UNITED STATES PATENT AND TRADEMARK OFFICE

APPLICATION NO.	FILING DATE	FIRST NAMED INVENTOR	ATTORNEY DOCKET NO.	CONFIRMATION NO.
10/628,613	07/29/2003	Fraser Evans	MBT-105-B	5830
7590	05/01/2007		EXAMINER	
Thomas N. Young YOUNG & BASILE P.C. Suite 624 3001 West Big Beaver Road Troy, MI 48084			CHAN, KO HUNG	
			ART UNIT	PAPER NUMBER
			3632	
			MAIL DATE	DELIVERY MODE
			05/01/2007	PAPER

DETAILED ACTION

Claims 1-4, 9, 10, and 12 as best understood stand rejected under 35 U.S.C. 102(b) as being anticipated by Asamoto (US patent no. 3,945,676).

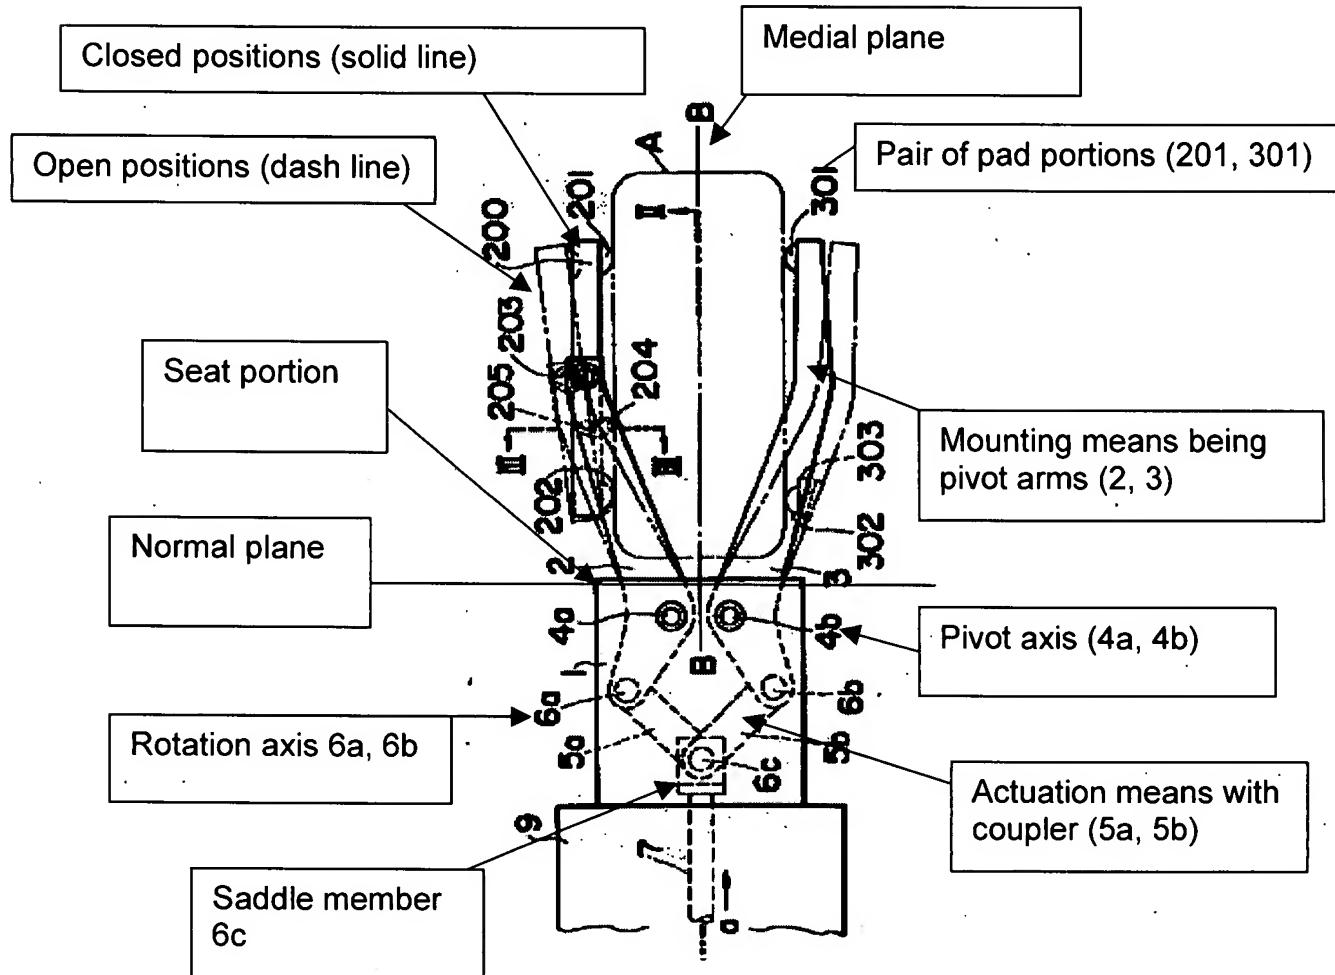
Asamoto discloses a clamp apparatus having all the claimed features of applicant's invention as illustrated below.

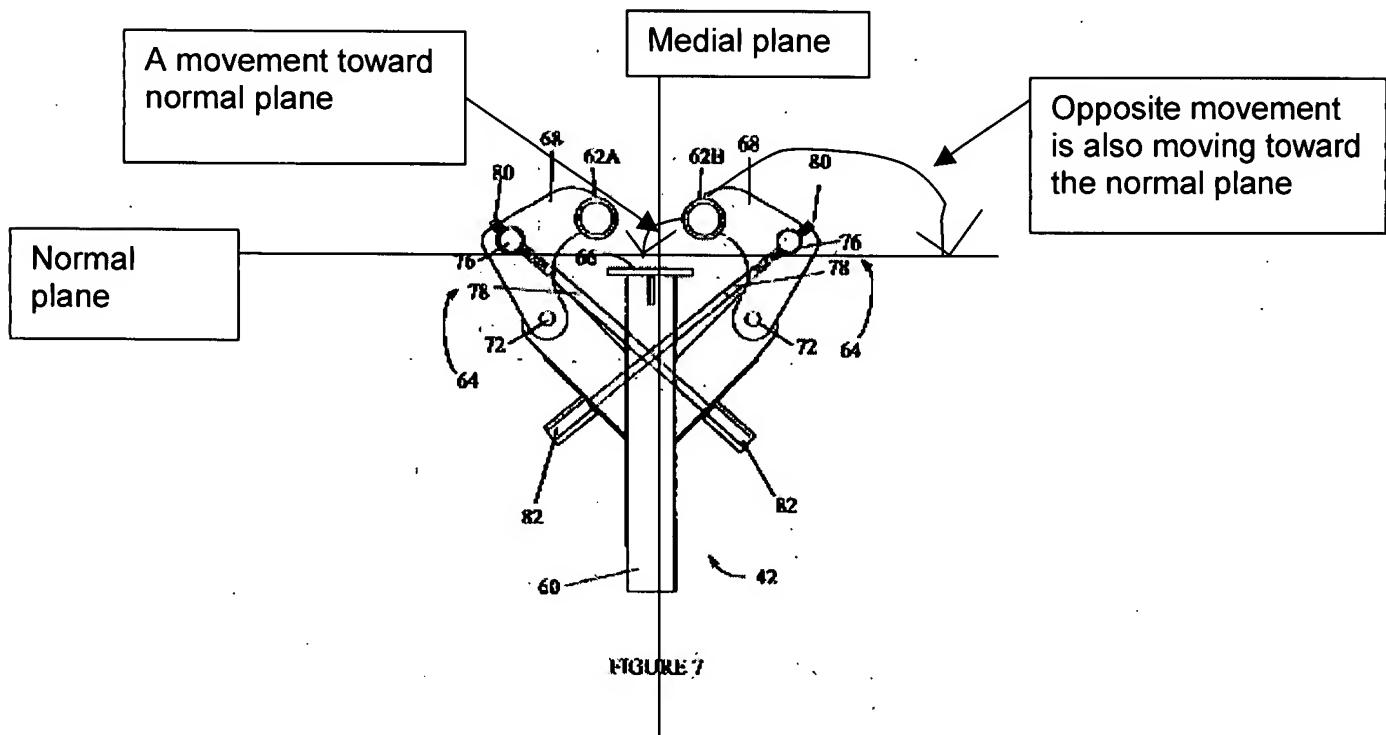
Applicant's arguments filed 4/11/2007 have been fully considered but they are not persuasive. Applicant argues that Asamoto does not show the pad portions move away from the normal plane, from the closed positions to the open positions, at least the second pad portion move away from the medial plane. Examiner has noted the following; In claim 1, applicant's newly added recitation "wherein during movement **from the open positions to the closed positions**, the first pad portion moves in a direction away from the normal plane, and the second pad portion moves in a direction away from both the medial plane and the normal plane" in claim 1, second paragraph which appears to be contradictory to claim 9 which says that "during movement **from closed positions to open positions**, the pad portions move (also) in a respective directions ways from the normal plane and the medial plane".

However, such does give examiner new insight on the claim language. The medial plane and the normal plane extends through to either side of the pad motion, such that the pad can be said to move away or toward the planes from the closed to open or vice versa which says such limitation is meaningless as direction goes and does not overcome Asamoto at all. (see illustration below).

Again applicant's recitation does not overcome Asamoto as illustrated above. Movement of the pad portions can be said to be moving towards and away from a particular plane at the same time where such plane extends through the fulcrum of the swing arm with the pad portions on its left and right side as illustrated above. If the arm

is swinging right then it can be said the arm is moving towards the right portion of the plane but away from the left portion of the plane and vice versa.
